UNITED STATES
NUCLEAR REGULATORY COMMISSION
WASHINGTON, D.C. 20555-0001

SUBJECT: TECHNICAL REVIEW OF FINAL INVENTORY AND SPECIAL
ANALYSIS DOCUMENTATION FOR TANK 12H at SAVANNAH
RIVER SITE (DOCKET NO. PROJ0734)

Technical Review of Final Inventory Documentation Supporting Tank 12H Closure

Date: October 2017

Figure 1 Sample Locations and Sample Numbers (Sample Numbers May Include the Following Letters: “R” for Replacement, “L” for Low Mound Sample, and “H” for High Mound Sample). Image Credit: SRR-CWDA-2015-00075, Figure 3.2-2.

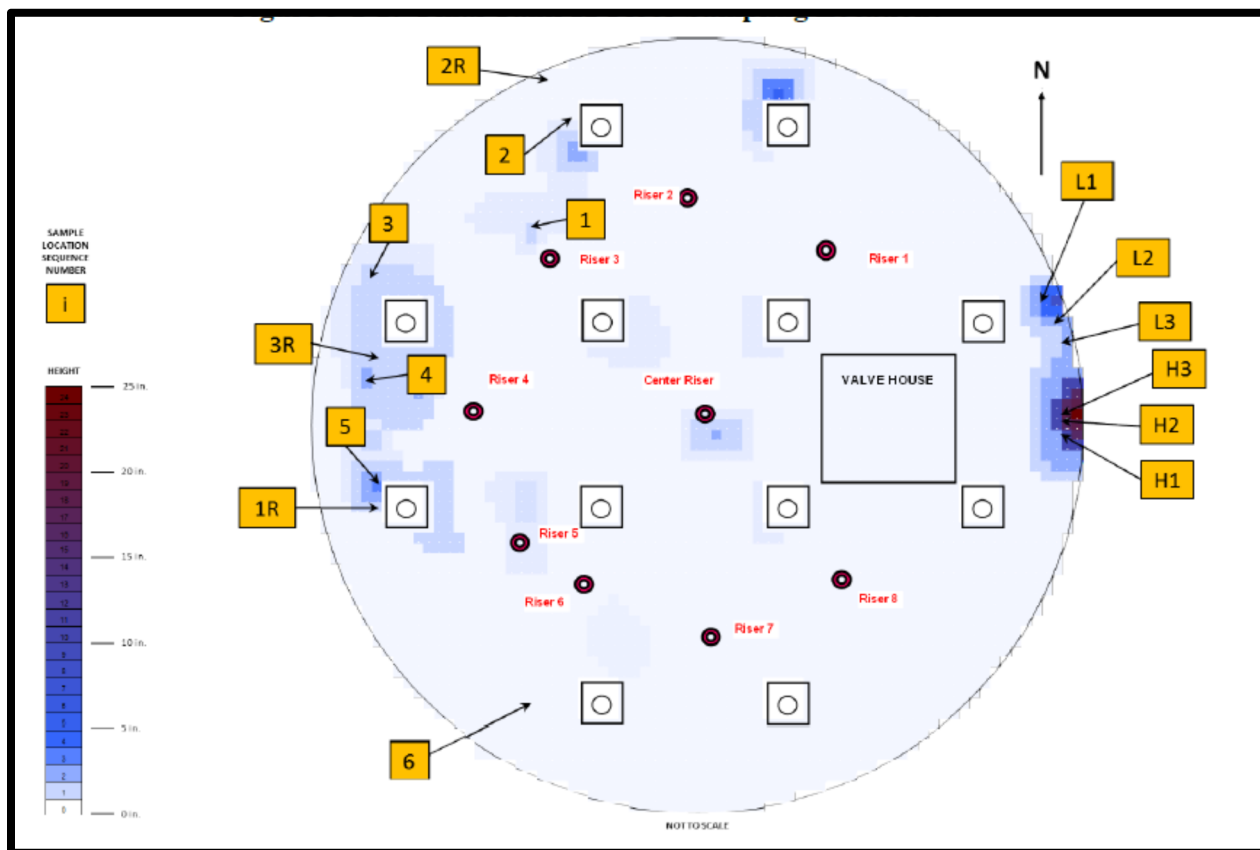
As indicated in previous TRRs, the staff continues to have technical concerns regarding the location and number of samples collected for each of the segments. DOE contractors continue to experience difficulty obtaining samples (e.g., DOE contractors were unable to collect one of six floor samples and did not clearly provide rationale for the number of samples taken from each segment). There may be a benefit from collection of more samples from segments with higher variability or greater volumes, but documentation was unclear on the basis of the sample locations. Initial volume estimates for the mound of residual waste located in close proximity to the valve house was significantly underestimated, as was the case for a similar residual waste mound remaining in previously cleaned tanks (e.g., Tanks 5F, and 6F). Significant errors in preliminary estimates of the relative volumes of segments may negatively impact decisions regarding the number of samples taken from the segments. The staff also noted that material was collected from three boulders on the crawler's path towards the residual waste mound and assumed to be representative of the bottom of the mound. It is unclear whether any samples from the bottom of the mound were attempted or simply assumed to be unnecessary. If the material from the boulders was not representative of the bottom portion of the mound, the composite samples would not well represent the mound concentrations.

Figure 2 Final Distribution of Solids Used to Determine Residual Waste Volumes for Tank 12H. Legend Provides Thickness of Waste in Inches (1 inch=2.54 cm). Adapted from Attachment A of U-ESR-H-00125.

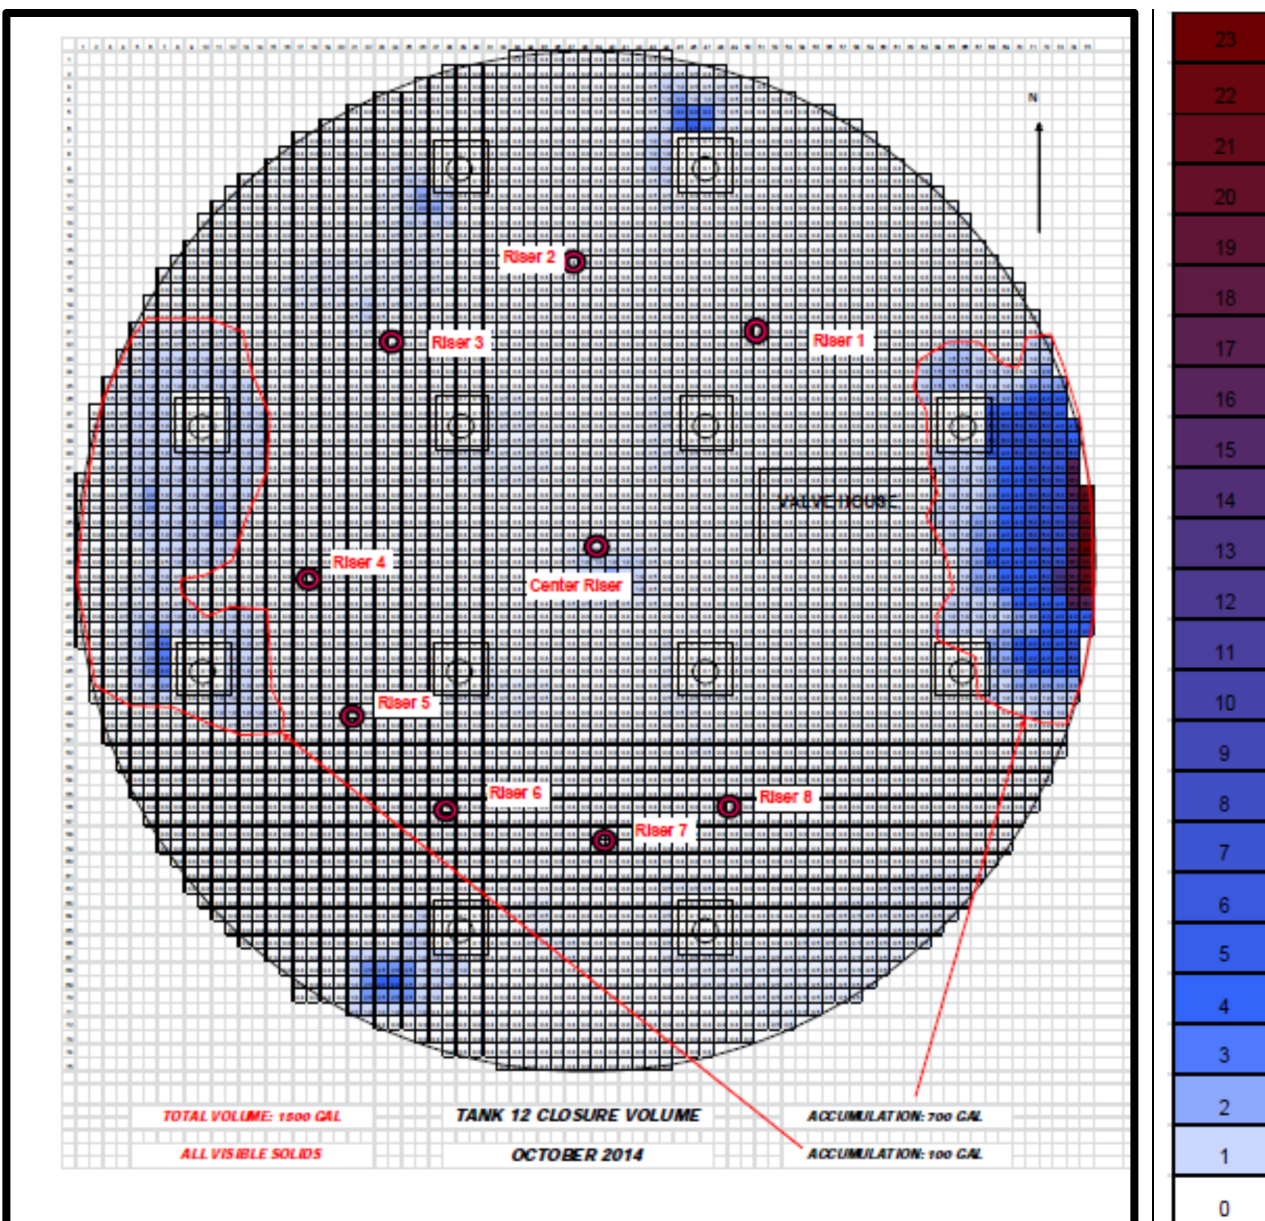
Although the best estimate floor volume proportion is around 53 percent (800 gallons [floor] / 700 gallons [mound] + 800 gallons [floor]) (3000 liters [floor] / 2600 liters [mound] + 3000 liters [floor]), the mass fractions of the floor samples used in the composite samples range from 65 to 85 percent (see last column in Table 4) owing primarily to the large differences in densities of the floor and mound samples. However, information on uncertainty in density measurements was not provided, nor was it considered in the volume proportional compositing scheme. Lack of consideration of density uncertainty could be important because of the large variance in density measurements with density of floor samples (range from 0.93 to 1.97 g/ml for the 146 hour air dried bulk density values reported in Table 2 of SRNL-STI-2015-00241, which were used in the compositing protocol [see Tables 4-5 to 4-7 in SRR-CWDA-2014-00103]) being significantly higher than density of mound samples (range from 0.54 to 0.75 g/ml for the 24 hour air dried bulk density values reported in Table 3 of SRNL-STI-2015-00241, which were used in the compositing protocol [see Tables 4-5 to 4-7 in SRR-CWDA-2014-00103]). Composite samples with a disproportionately high mass fraction of floor samples could lead to an underestimate of key radionuclide concentrations because the mound samples may have higher key radionuclide concentrations compared to floor samples particularly for more soluble species (due to limited accessibility and consequently less washing of waste associated with mounds).

Figure 3 High Resolution Photo from Center Riser Taken In August 2013. Image Credit: U-ESR-H-00125.

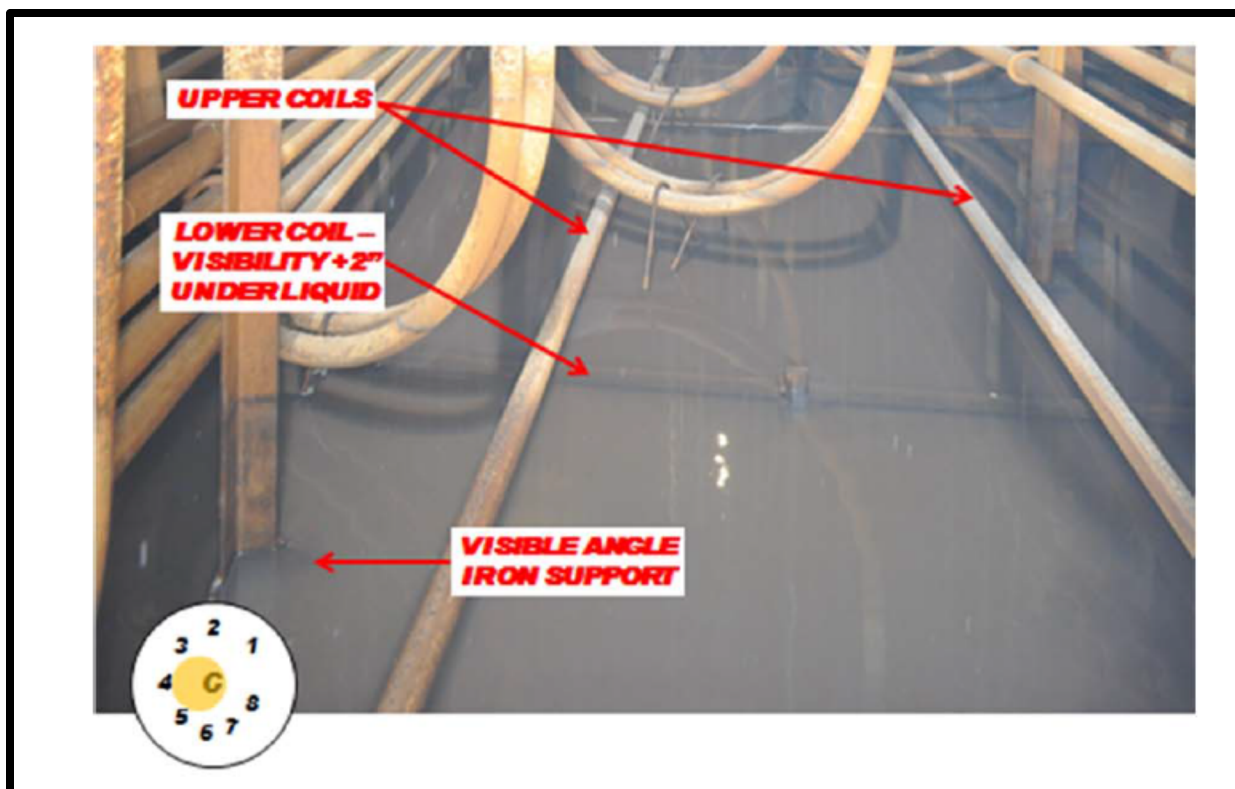
In most areas of Tank 12H, the solids level was below the liquid level when tank solids were mapped (see for example, Figure 3). The presence of liquid waste made it more difficult to map residual solids compared to a situation where significant quantities of liquid waste are not present in the tank. It is unclear why mapping occurred during this time period. Documentation should be more transparent regarding decision-making with respect to when tank solids are mapped, and why mapping occurred while there was still a significant quantity of liquid waste remaining in Tank 12H.
